NOTICE OF DECISION

Tyee Landing
TUM-23-0438
June 12, 2024

TYEE LANDING, LLC
TYEE LANDING APARTMENTS
SITE IMPROVEMENT PLAN

RE: Tyee Landing Apartments – TUM-23-0438 9,800 sq. ft. commercial and 148 residential units with leasing office within seven structures.
Formal Site Plan Approval
Vacant land equaling approximately 5.3 acres located west of Toyota of Olympia and northwest of Tyee Drive. Tax parcel numbers 12703320200, 12703320202, & 12703320203

SP-01
 SHEET 2 OF 4

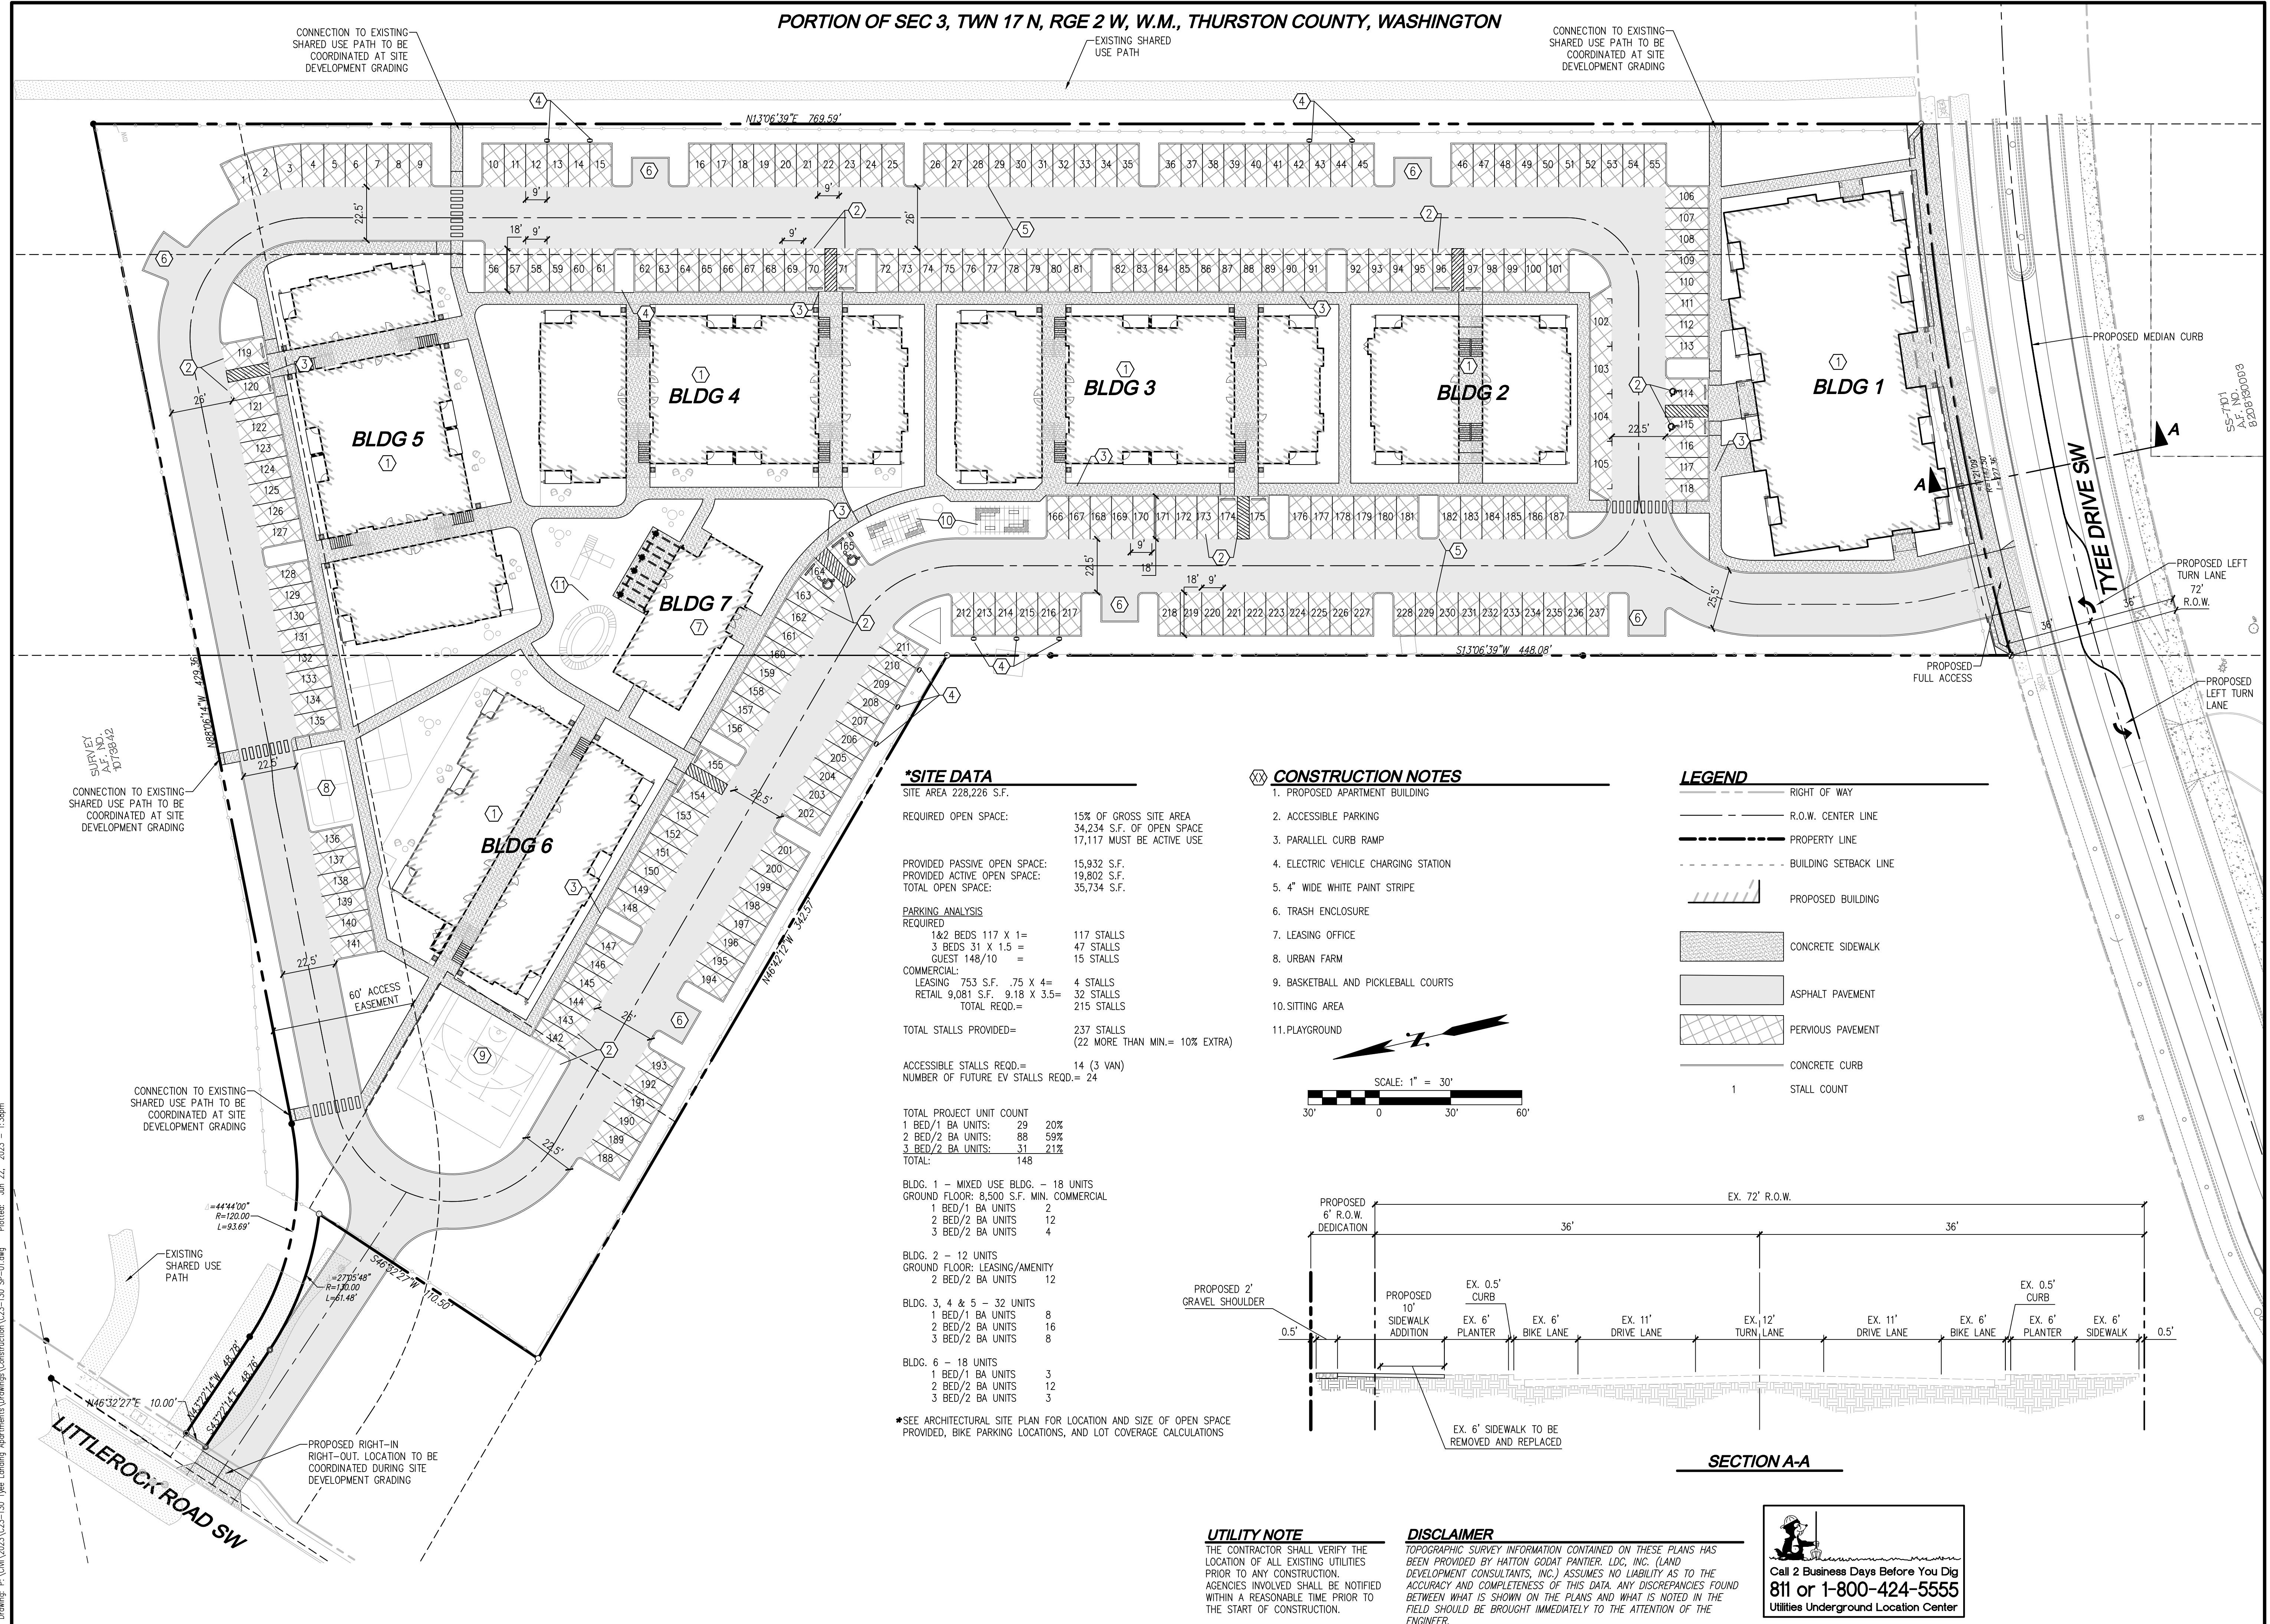
1. The proposed buildings are required by code to be provided with automatic fire alarm systems, including pull stations, throughout.
2. The proposed buildings are required by code to be provided with NFPA 13 fire sprinkler systems throughout. IBC 903.2.8. (site plan shows no sprinklers for Leasing building 7) need sprinklers/alarms for over 7500 square feet.

3. The applicant shall show the location of the Fire Department connection, post indicator valve, for building 7, Ductile iron pipe is required from the fire apparatus into the structures.
